LEGAL NOTICE EXETER PLANNING BOARD AGENDA

Date: July 2, 2024
To: Planning Board
From: Dave Sharples, Town Planner
Re: Meniscus Financial Holdings LLC – 127 Portsmouth Avenue
PB Case #24-1

Re: Foss Motors – 127 Portsmouth Avenue – Commercial Site Plan
Response to Third Round of Underwood Engineers Comments

SITE PLAN

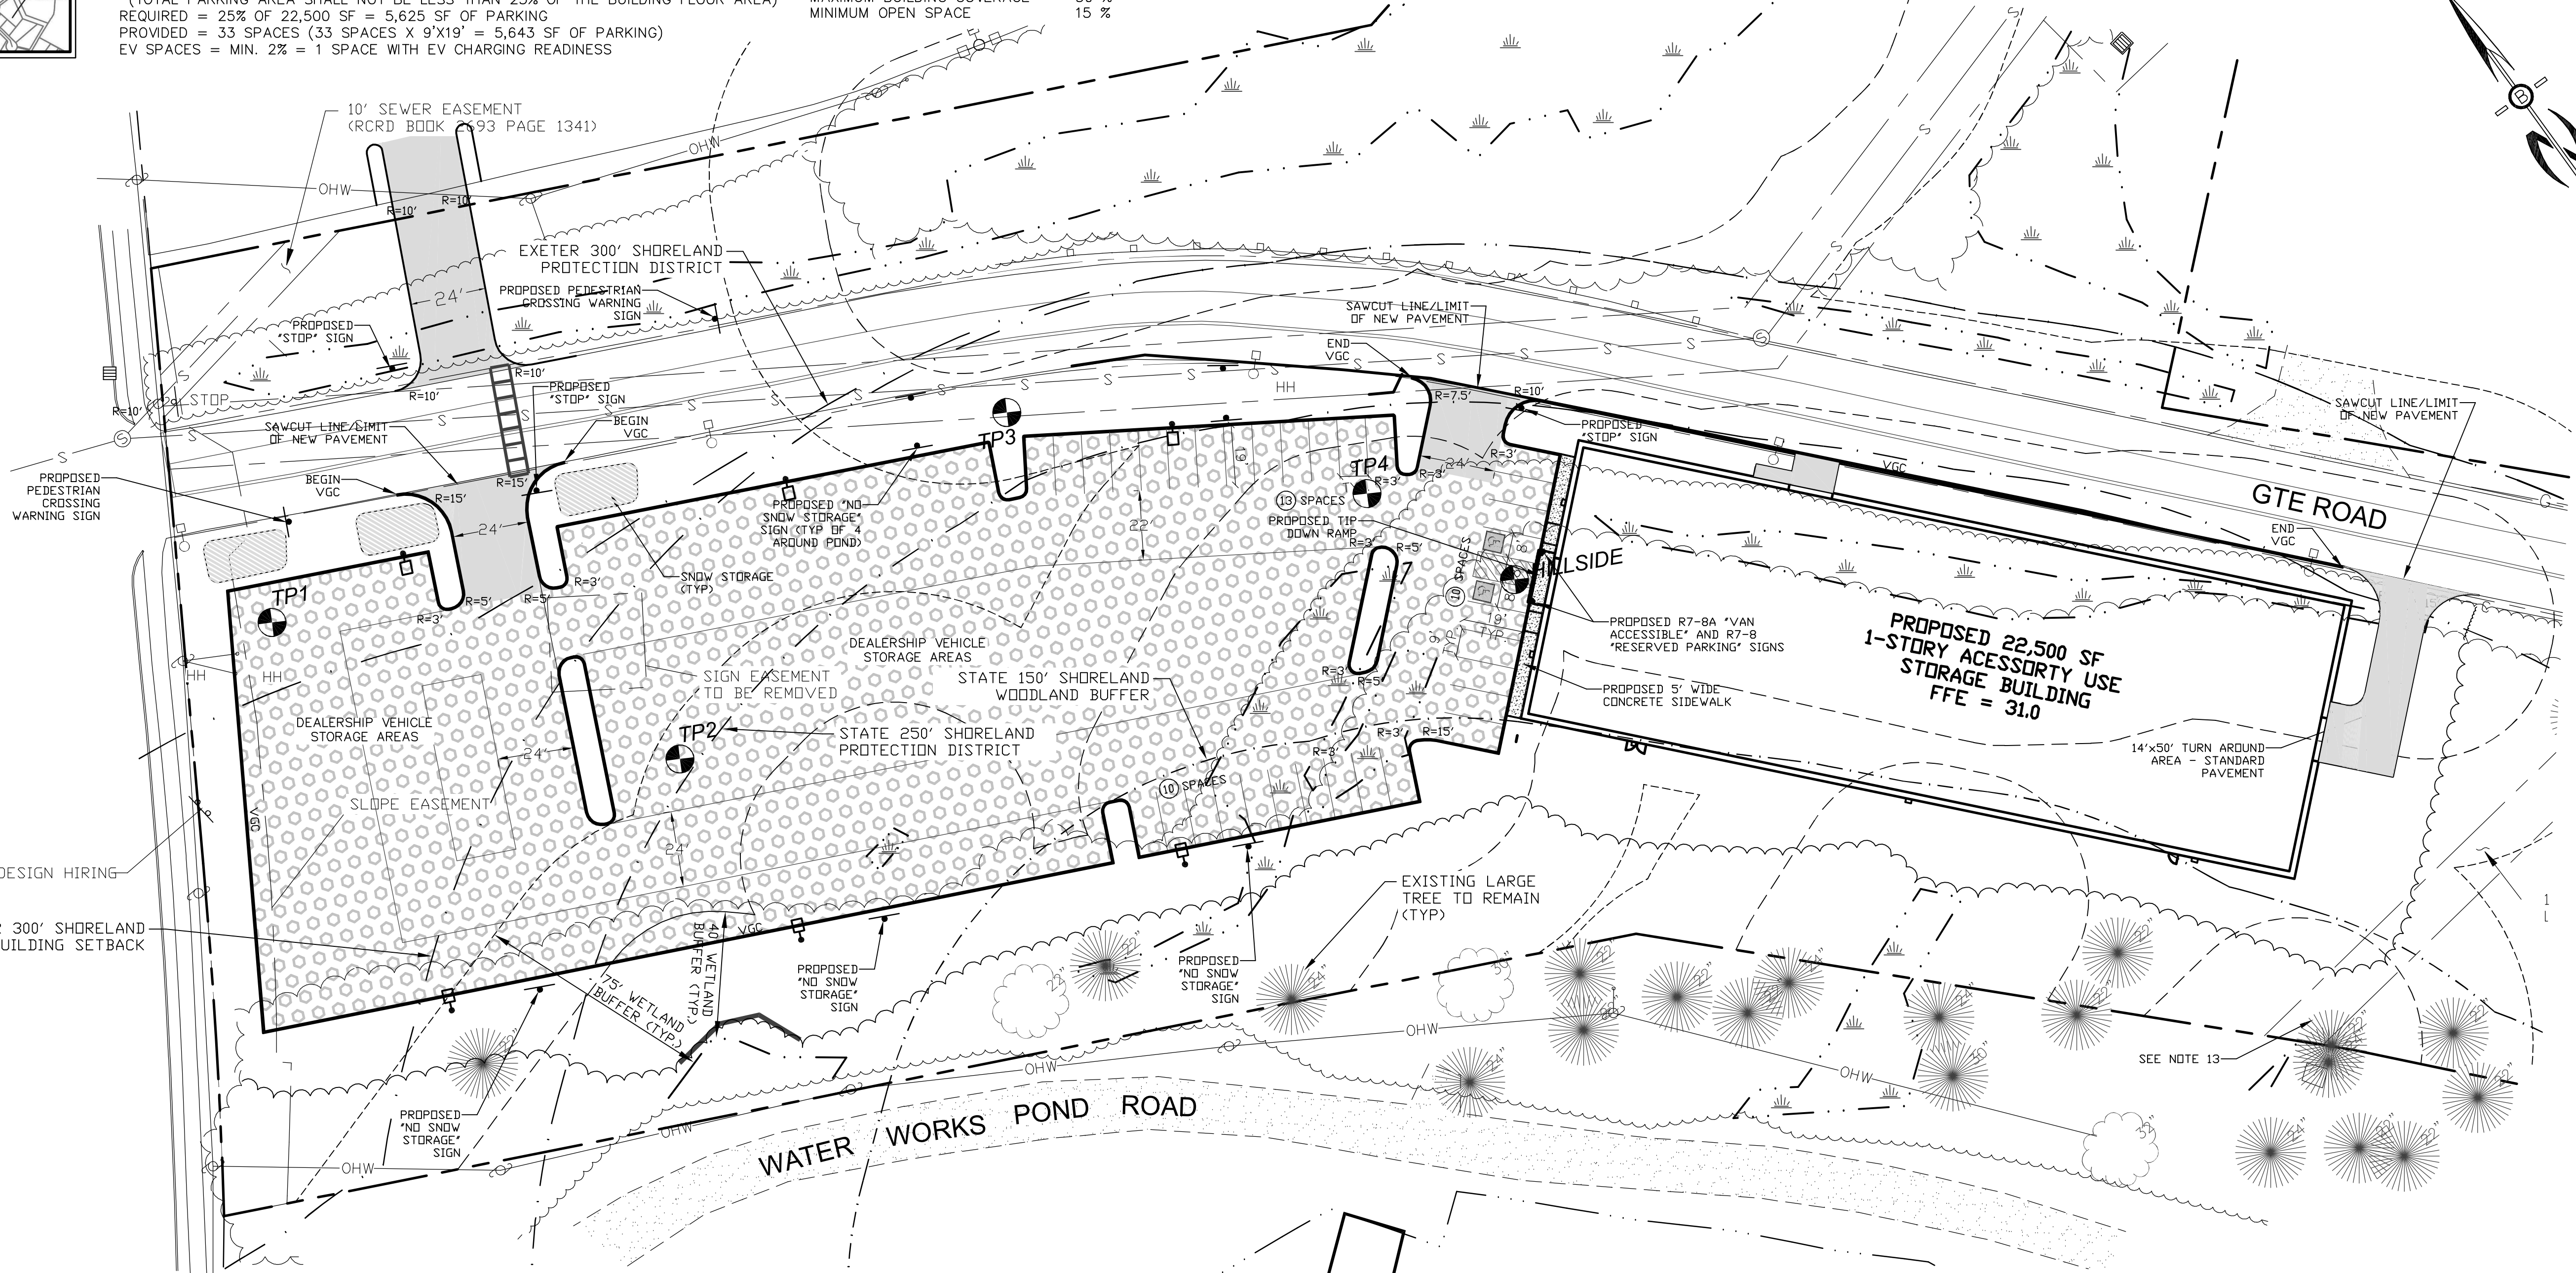
- 10.** It has been indicated that vehicles may be stored inside the building. No architectural plans have been received. It is unclear how and where the vehicles will be driven into the building.

The schematic elevations and floor plan indicate an overhead door and a man door on the eastern end of the building. The site plan includes a fire truck turnaround area on that end that does not extend to the overhead door. Since vehicles will be driven into and out of the overhead door, the pavement should be extended, including a turnaround area past the door to prevent backing out onto GTE Road.

47. Signs restricting snow storage should be added within the Shoreland Zone. See also related comment below.

Response: The site plans have been coordinated with the latest architectural plans, including overhead and man door locations.

Response: “No Snow Storage” signs have been added along the southern end of the parking lot and around the Bioretention Pond.

GRADING, DRAINAGE, & EROSION CONTROL PLAN

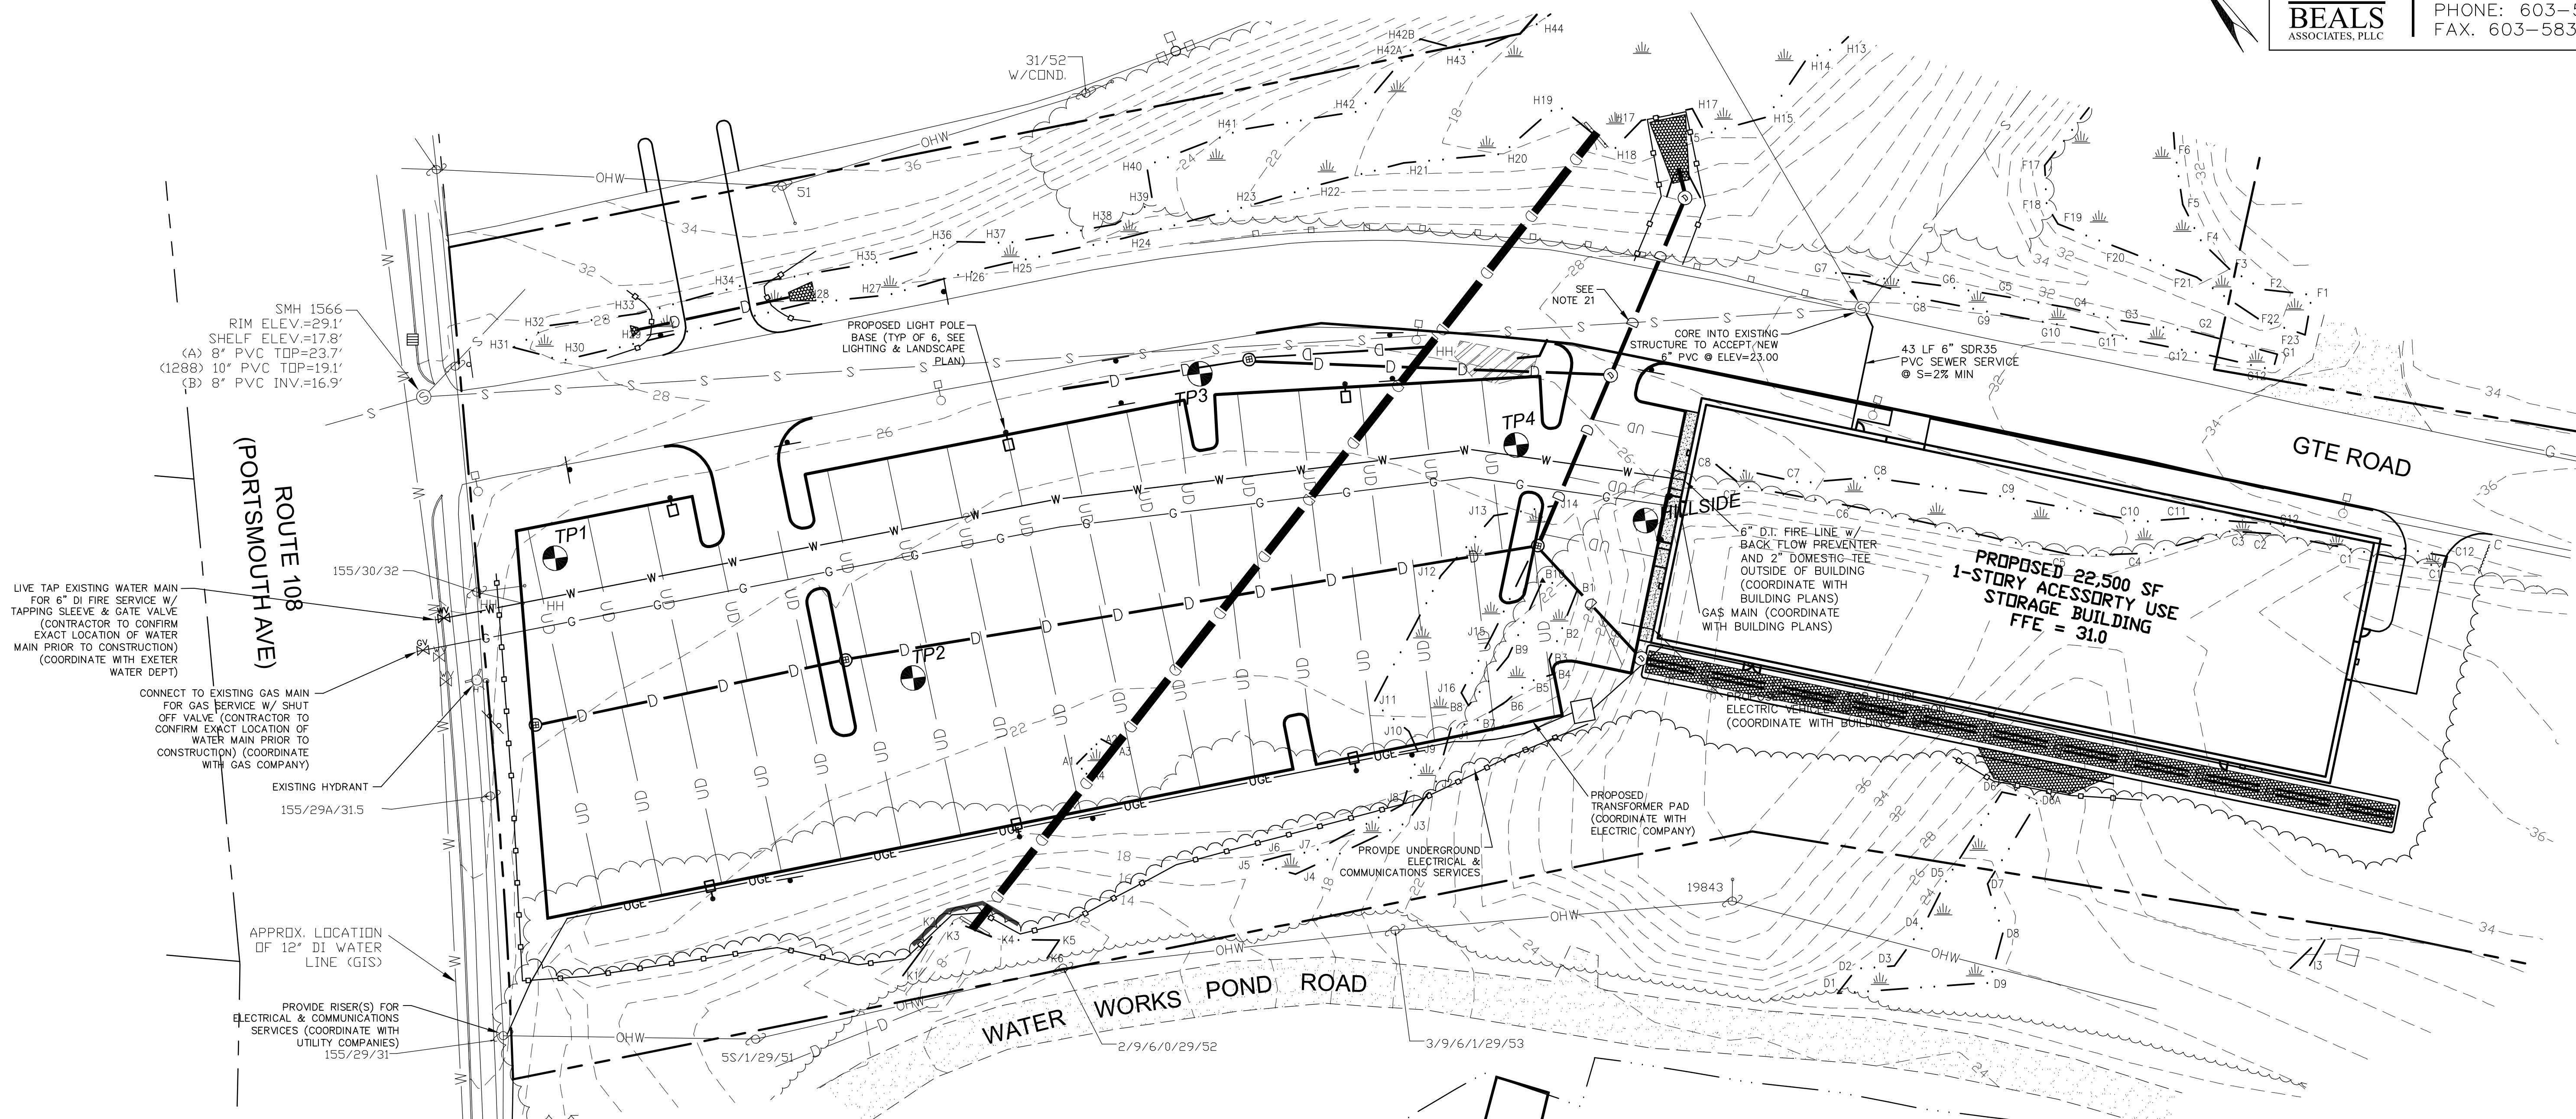
- d. The detail notes the depth as 30”, whereas the plan indicates 42” depth. The drainage model storage area should be adjusted as necessary.

- e. The underdrain and the drain manhole are approximately 4’ to 5’ from the existing sewer line. Insulation is recommended.

Response: The callout has been revised and the drainage model storage area has been verified.

Response: Limits of insulation between the sewer pipe and the bioretention pond system have been added to the Grading, Drainage, & Erosion Control Plan (Sheet 3).
